**STAFF REPORT:** 12/13/2023 REGULAR MEETING

**APPLICATION NUMBER:** HDC2023-00101 **VIOLATION NUMBER:** 669

**ADDRESS:** 2465 CHICAGO

**SCOPE:** ALTER FRONT PORCH AND LANDSCAPING, INSTALL SECURITY CAMERAS

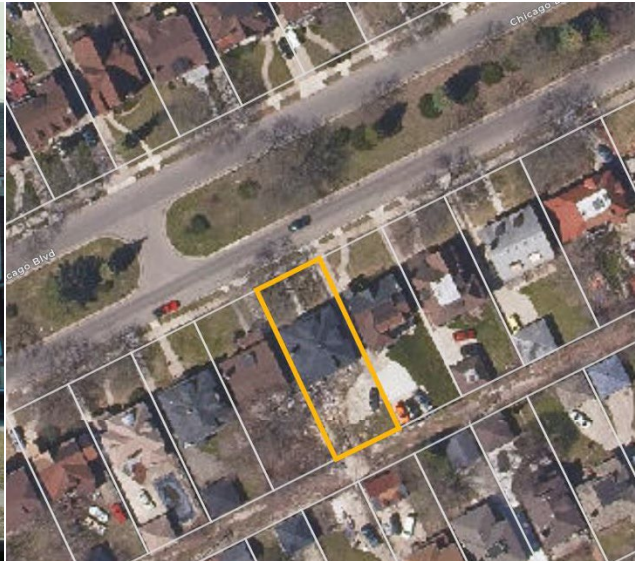
- Staff has the opinion that the original front porch, with its asymmetrically positioned raised, rectangular front floor/deck with the metal railing, brick piers with cast stone detailing that matches the house, matching brick clad wingwalls and wingwalls are historic, distinctive character-defining features. The removal of this feature, although completed without approval by a previous owner, and replacement with diagonally placed wingwalls with curvilinear steps is not appropriate, as this greatly alters the design and scale of this historic property, leaves scarring to the front façade, and creates a barren foundation. (See photos 1-5)

- Although the above photos indicate that the front porch had a wood roof and columns at the time of designation, staff has the opinion that this feature is not historic, and its removal is appropriate. Through careful reading of site and historic photos, staff perceives an outline of a Juliette balcony railing that may have been attached to the front façade of the house. Although photos of this condition were not found, a potential example of this feature can be inferred from the main entrance of a neighboring house at 1686 Chicago. (See photos 6-7) Staff recommends that the scars may serve as an informative outline to repair the pediment and pilasters around the top of the entrance. While the removal of the wood porch roof and columns is appropriate, staff has the opinion that this area of the front entrance requires attention and that leaving this area empty is not historically appropriate.

- Re: the current plant beds that flank the front porch, while staff agrees that positive drainage should be encouraged to pitch water away from the house, the loose stacking of concrete block as raised beds in place of the front porch, is not an appropriate replacement for the original front porch, in staff's opinion. If the Commission decides that the current conditions of the lost front porch can remain, staff recommends that a more permanent structure which utilizes brick cladded walls with cast stone coping to match the materiality of the home be used to retain the existing plant beds. The footprint of the retention walls should be rectangular, to reference the former porch, and the plantings should reach a height which screens the scarring left by the removal of the porch.

- Work in this application was completed without the Commission's approval.
- It is staff's opinion that replacement of the front porch with the new porch greatly alters and diminishes the home's historic character. Except for the wood roof and columns, the porch that was removed was original and thus was a character-defining feature of the home. If the porch was deteriorated, it should have been repaired in-kind. If it was deteriorated beyond repair, it should have been replaced with a new porch that exactly replicated the old. Therefore, the work does not meet the Secretary of the Interior's Standards for Rehabilitation.
- While removal of the nonhistorical roof and columns at the front porch is appropriate, staff has the opinion that leaving the front entrance in its current condition is not appropriate as it would have been sheltered by some sort of roof historically/originally.

- The original front porch elements that were removed without HDC approval were distinctive, character-defining features that characterized the property.
- The application does not include documentation that these historic features were deteriorated beyond repair to an extent that merited their replacement.
- If the porch had been shown to be deteriorated beyond repair, it should have been replicated to match the old.
- The removal of the non-historic wood porch roof and columns should have included a proposal to install a new roof of a design which is compatible with the home's historic appearance as the front entrance would have originally been sheltered by some sort of overhang.
